**Memorial Drive Greenway Improvements, Phase III**  
**Public Comments received by DCR**  
*deadline May 9, 2019*

**Between the BU Boathouse and the Eliot Bridge**

**Comments by WalkBoston**

# End of wide sidewalk just west of BU Boathouse

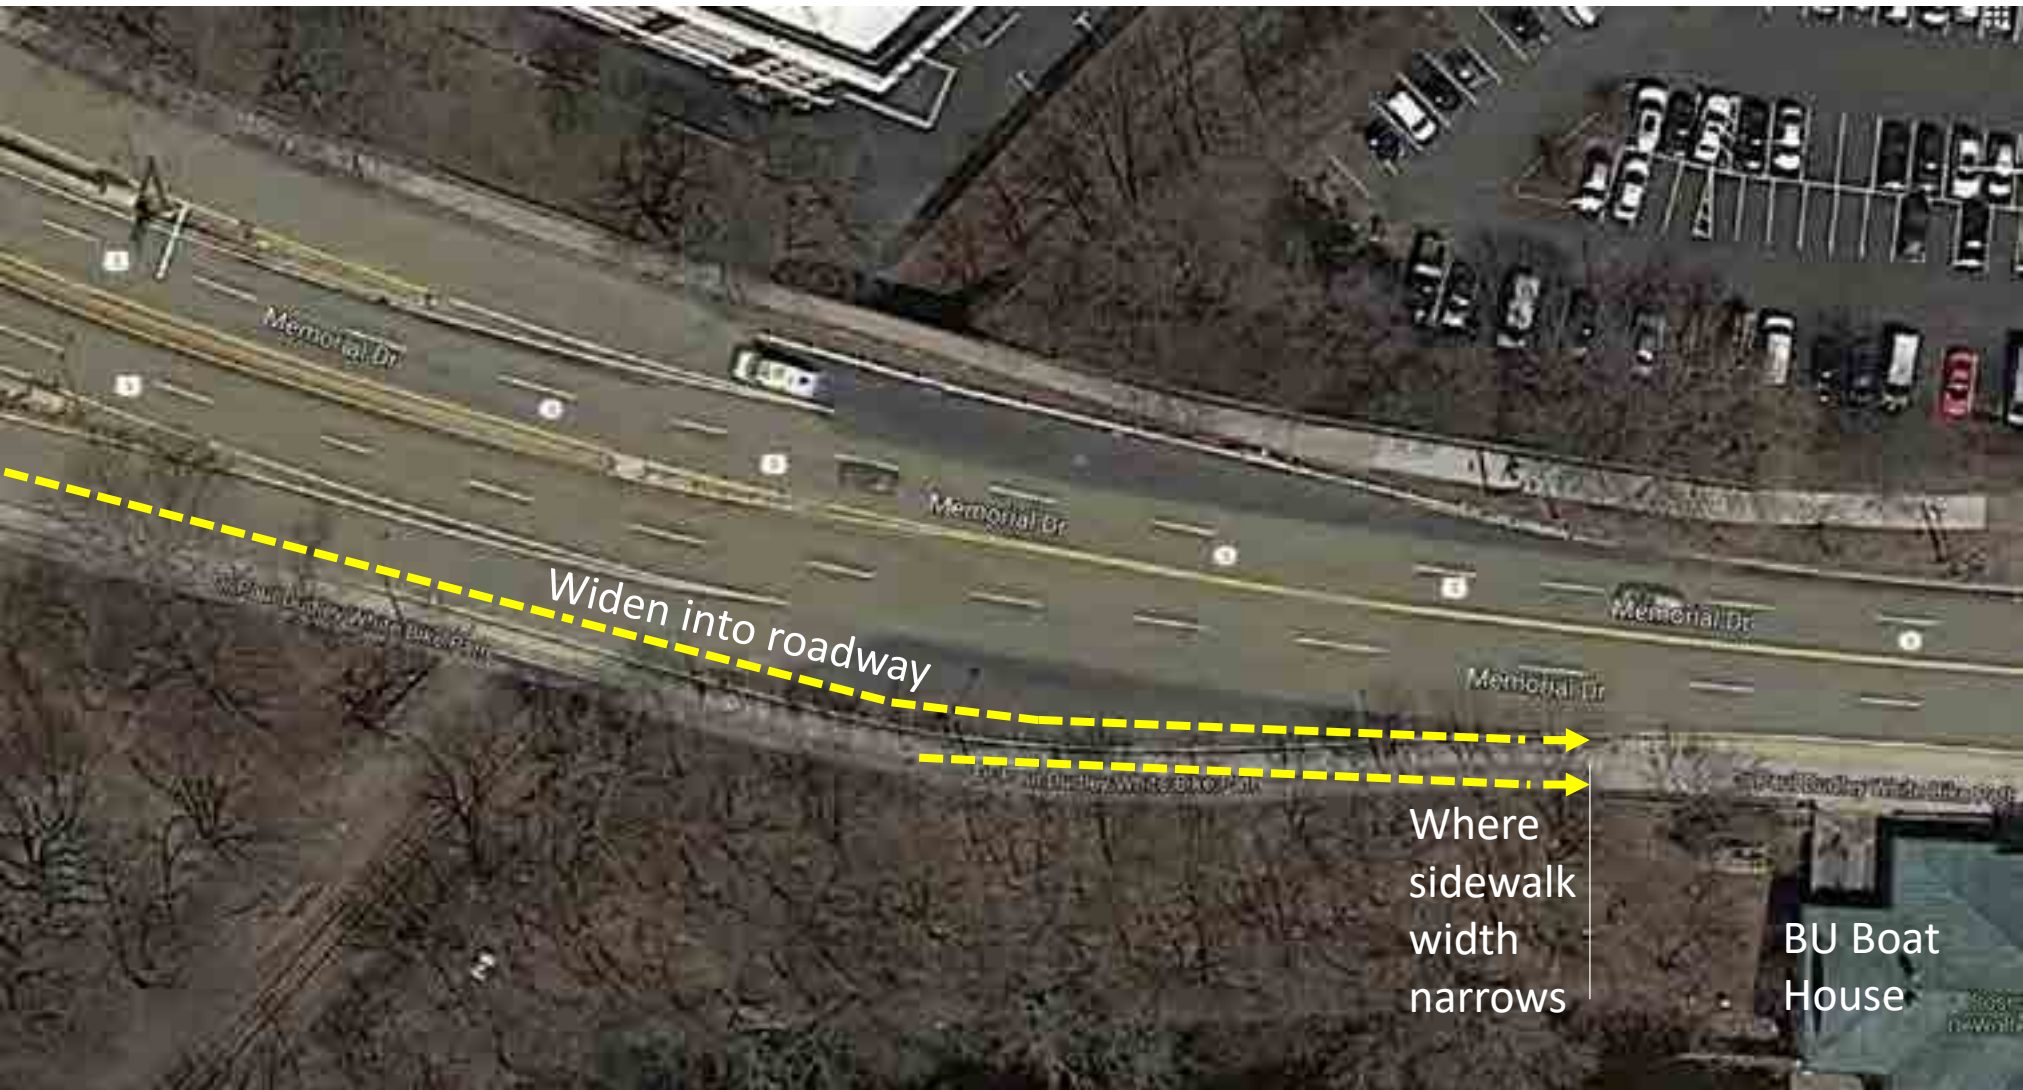
Widen onto hillside as was done at boathouse

Grand Junction Overpass

Widen into on-ramp

# BU Bridge to Grand Junction overpass

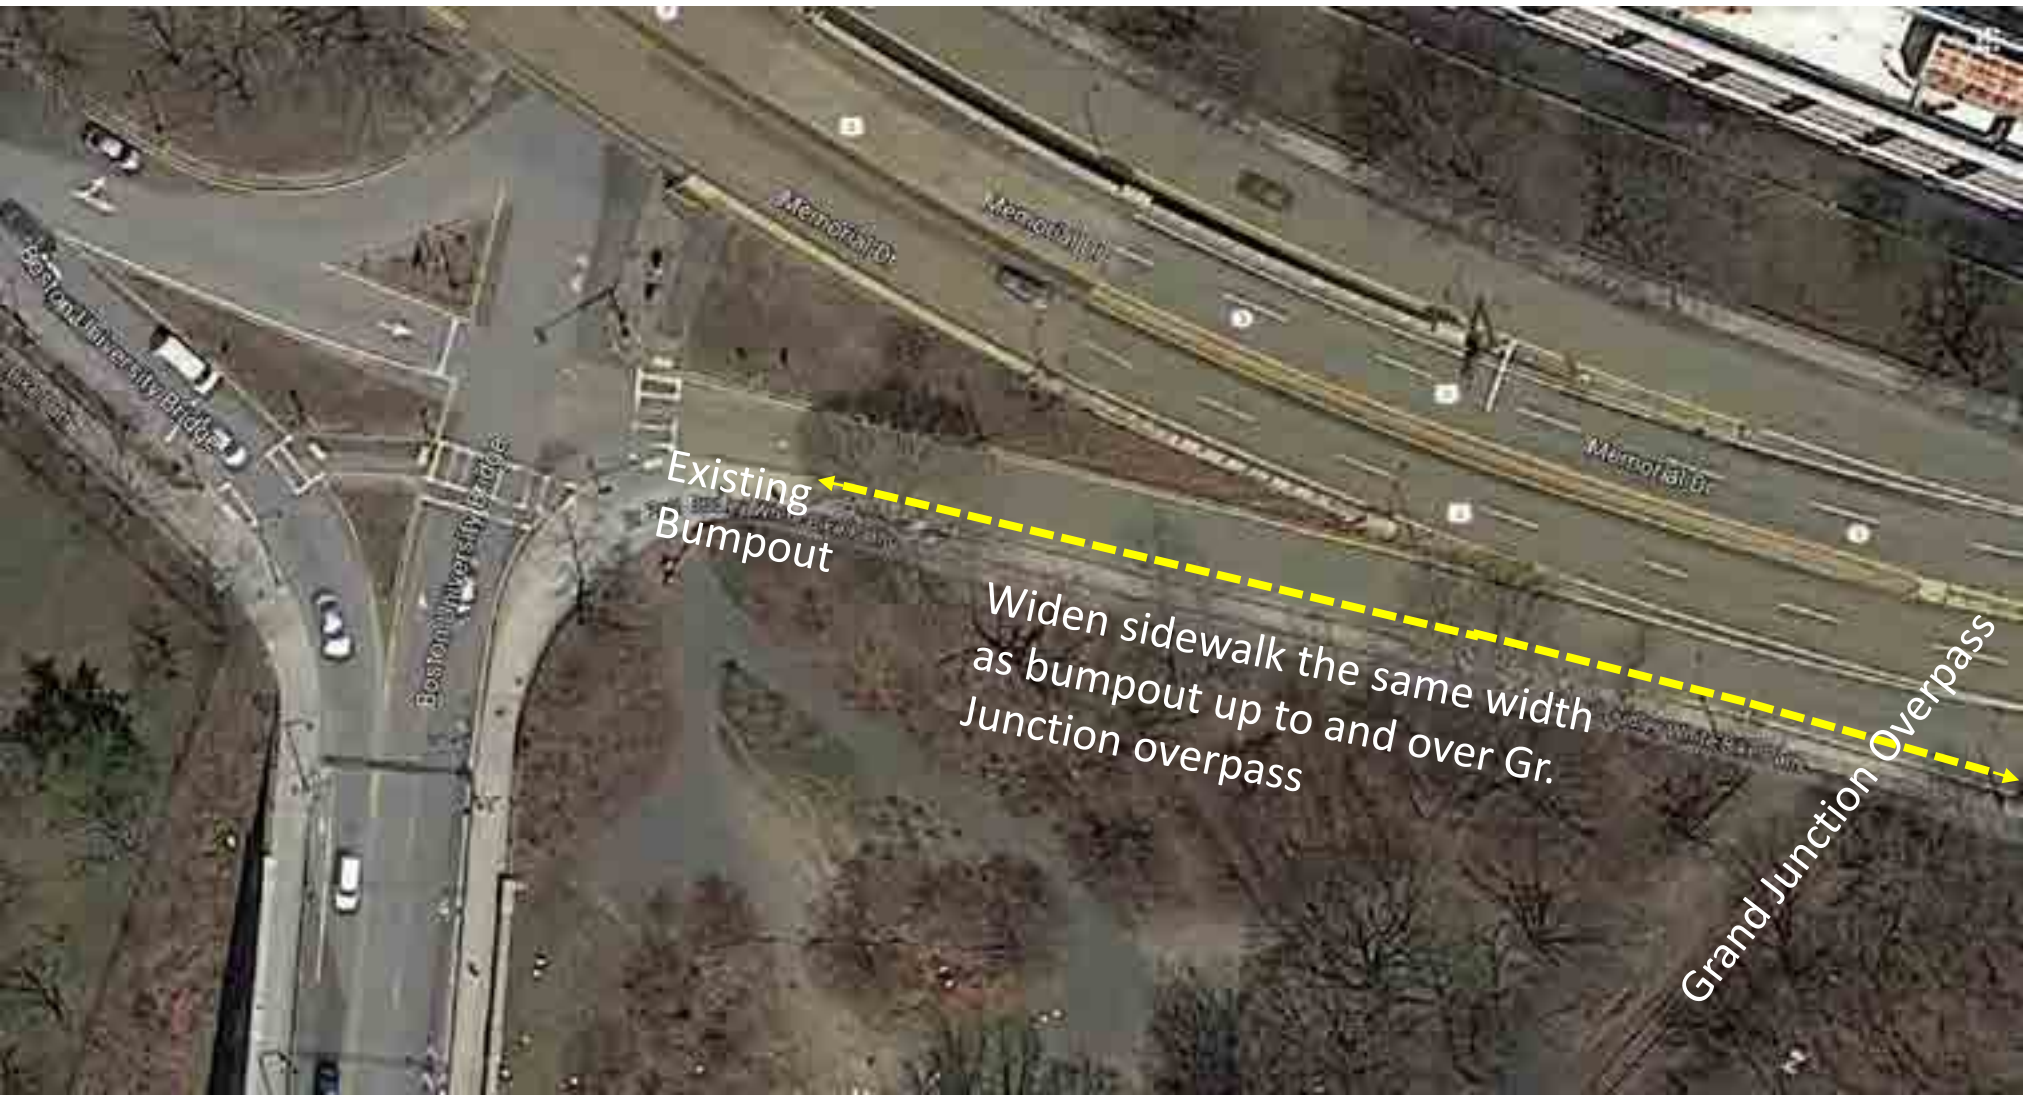
Existing  
Bumpout

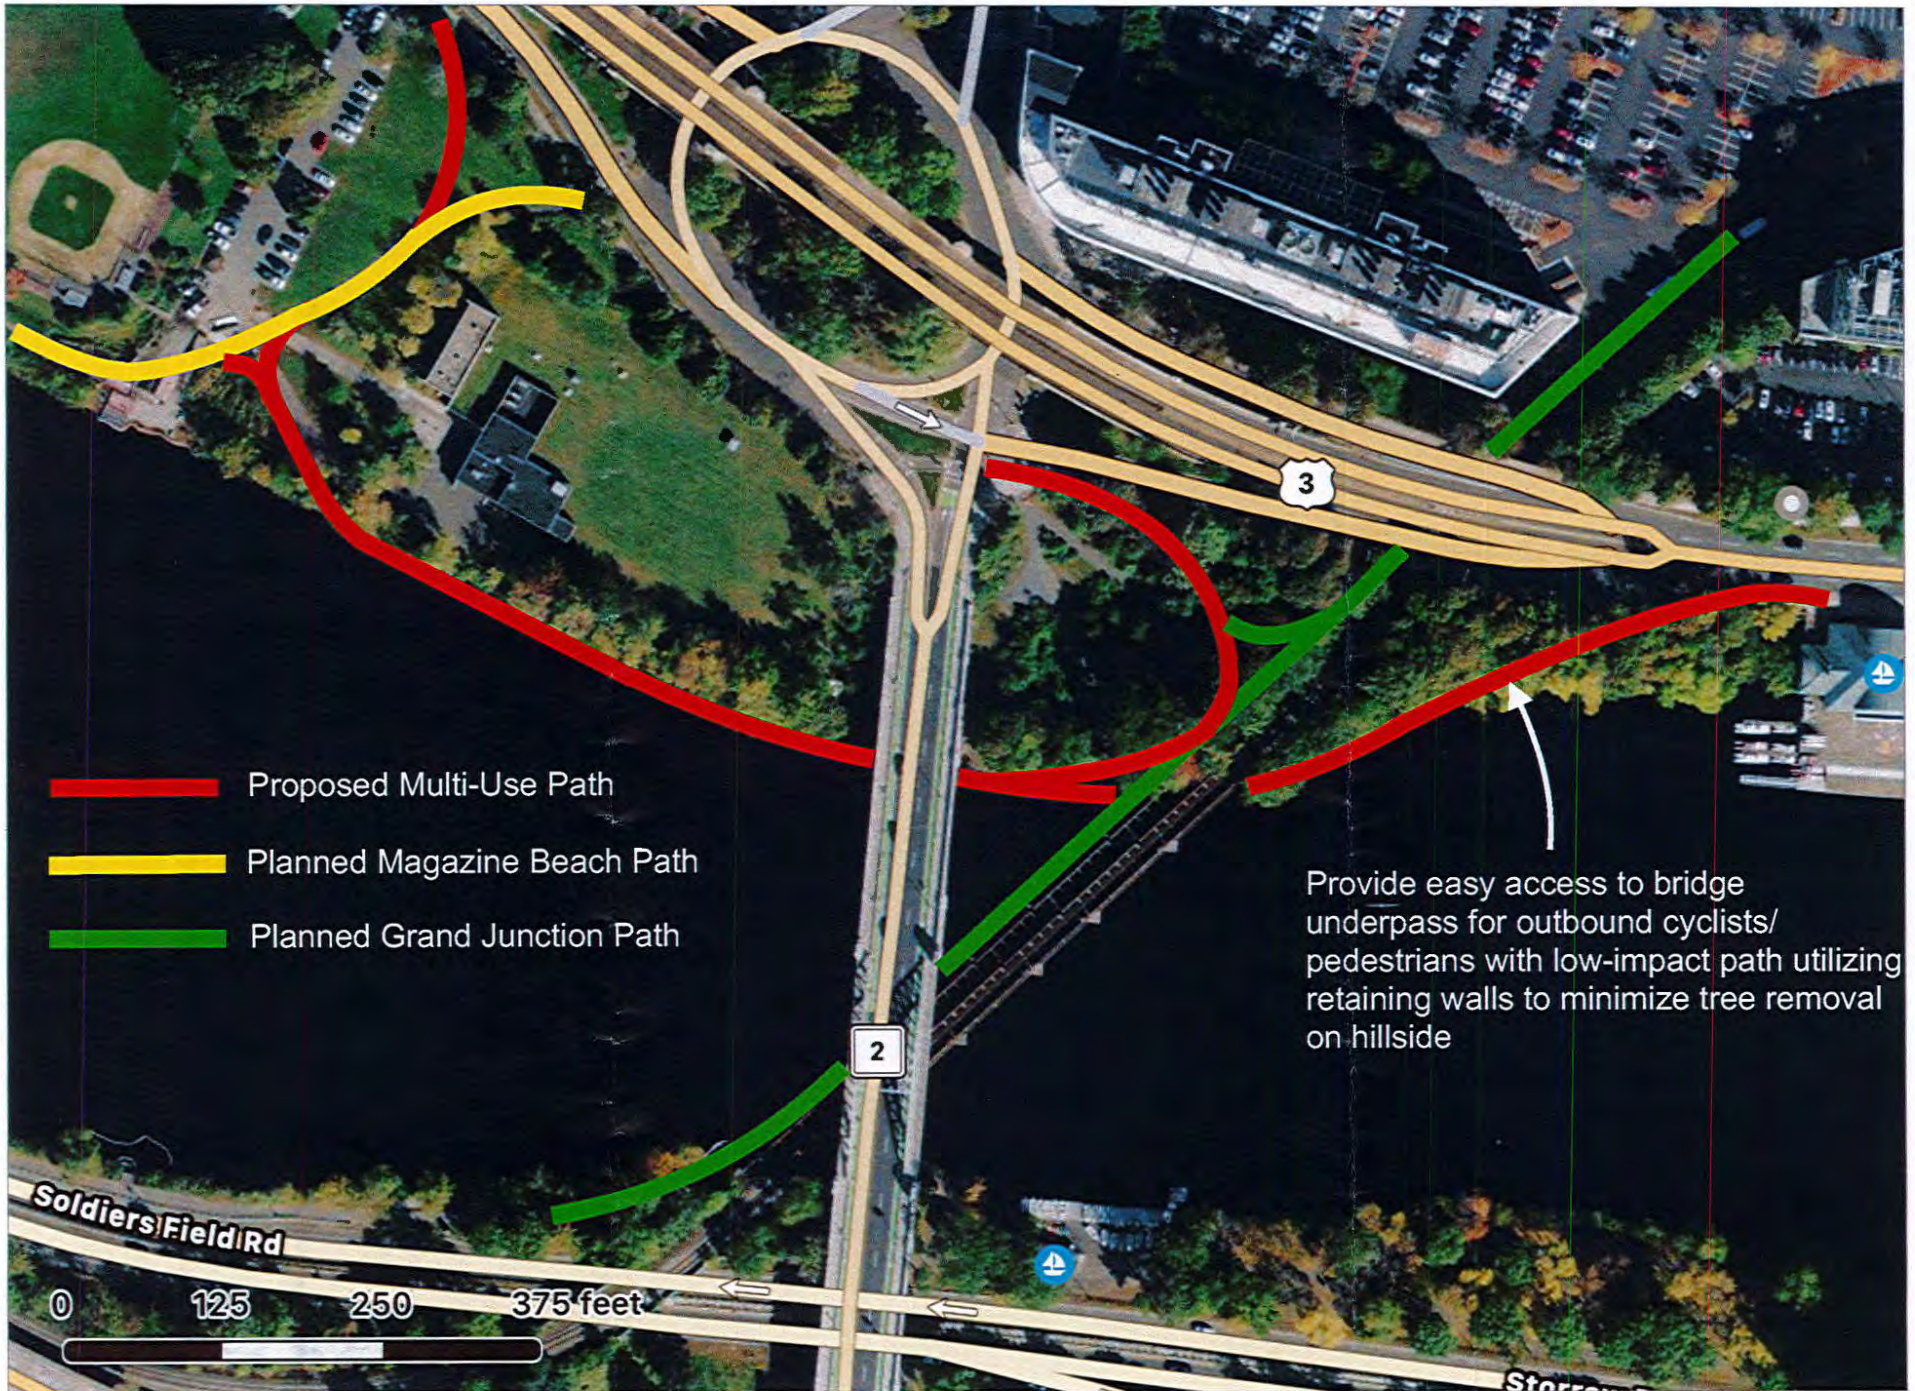
**Many of the issues relevant to the design of the M/U Path in this segment have been addressed in the design of Phase II improvements for Magazine Beach park.** This design effort also rigorously integrated other priorities and elements into that design that are specific to Magazine Beach. Great care should be taken to understand those priorities before proceeding with any redesign of this segment.

**Important Magazine Beach M/U Path priorities include:** avoiding removal of or damage to healthy trees to the greatest extent possible, creating better path separation from Memorial Dr along the entire frontage, creating identifiable park entrance nodes

and information kiosks at Brookline St, Magazine St footbridge, and Pleasant St in harmony with the overall park design vocabulary, integrating with seamlessly with all other elements of the Phase II plan for the park, and, of course, providing a significantly upgraded M/U Path adequate for its purpose and in accord with other similar path improvements along the river.
